Group submission relating to application SSD 5878

Sydney International Convention, Exhibition and Entertainment Centre Precinct – Mixed use Development in the Southern Haymarket Precinct (Concept Proposal) (SSD)

Mixed use Development in the Southern Haymarket Precinct (Concept Proposal) (SSD)

DEVELOPMENT APPLICATION
PEAK TOWER - NORTH ELEVATION
PROPOSED BUILDING PROFILE OVERLAY

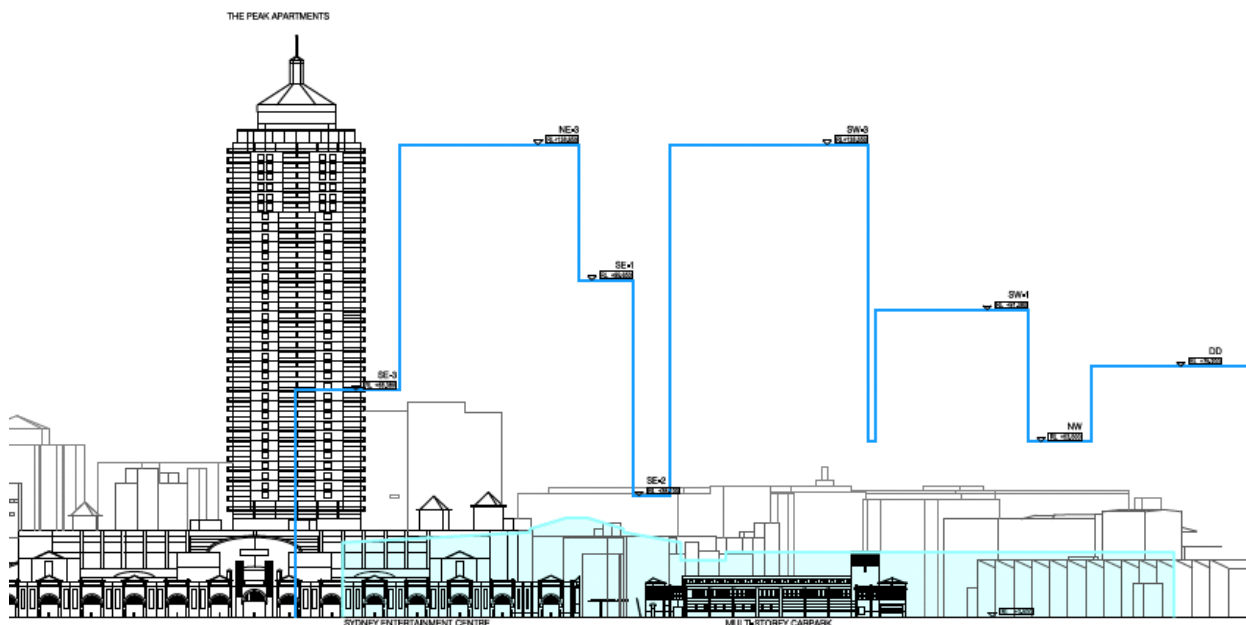
This shows these planning guidelines have been ignored in the drive for increased density and optimum placement of the new towers for maximum return - all with scant regard for the existing buildings.

The loss of amenities, outlook and views is an excessive burden on the residents of the Peak and for all the residents of surrounding buildings. At a minimum, it is imperative to delete the Tower SE1 from the planned development.

The following figure – buried in SSD 5755 illustrates the size of the proposal in relation to The Peak.

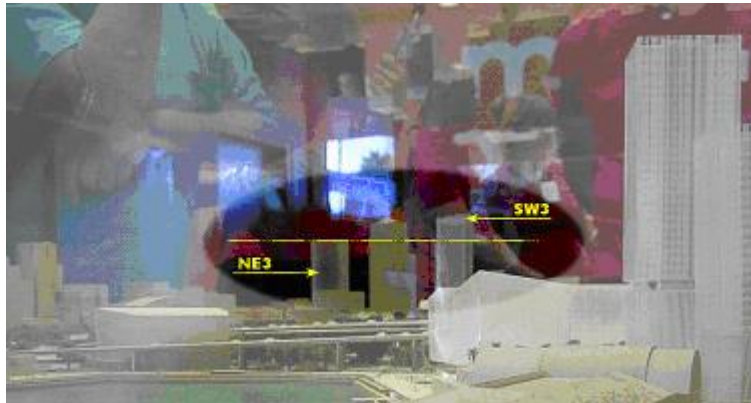
- *Views to the Powerhouse Museum will be affected by the two residential blocks in the Haymarket Precinct situated next to the Rail Corridor, which will also be impacted. Principal views to the Powerhouse Museum are available from Harris Street and will not be affected by the proposed development, while views to the building are of secondary importance.*

The student blocks and tower SW 1 will obscure the sight lines to the Museum from the southwest and the CBD. Why is it deemed sufficient to retain only the western façade when the eastern façade is the most important one.

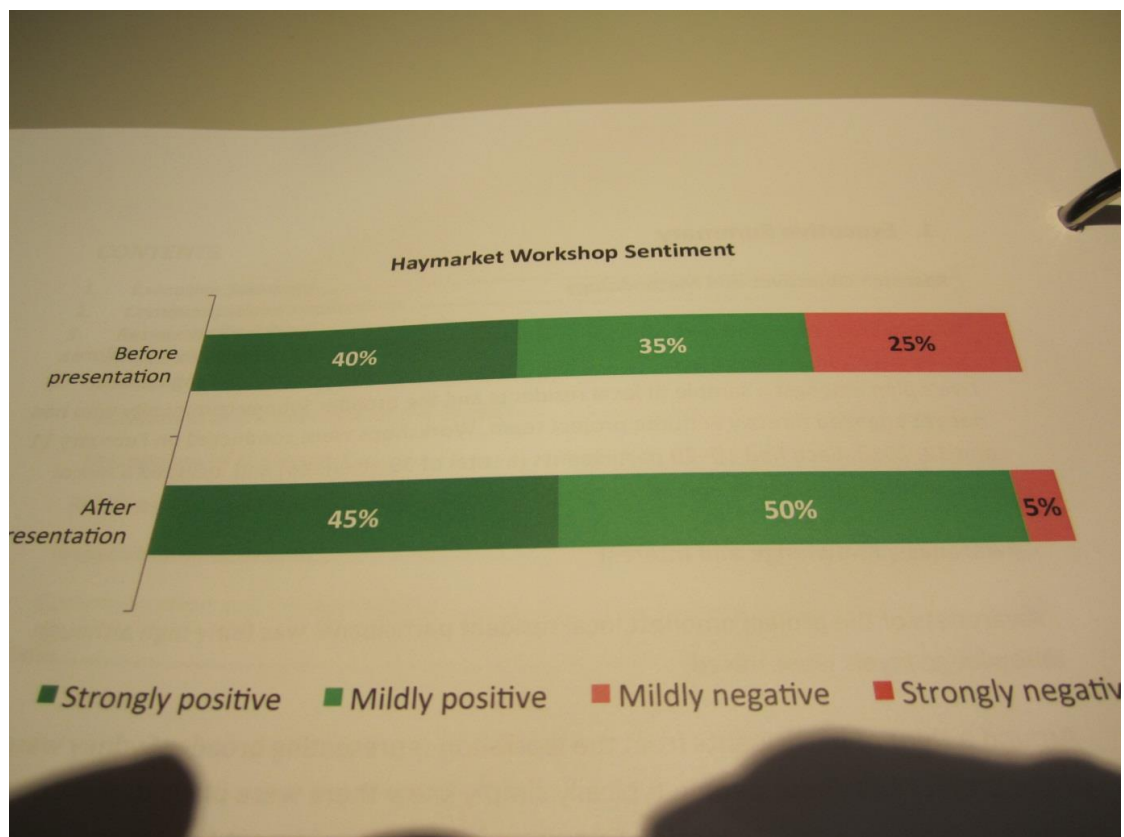
The information given during consultation was very much smoke and mirrors. The statements given on the height of the towers was vague and variable with the number of floors being defined from the podium level in some cases. The RLs of the top of the towers were not disclosed prior to the EIS being lodged. In fact tower NE3 grew about 8 floors after consultation. This is clear from photos of the original model.
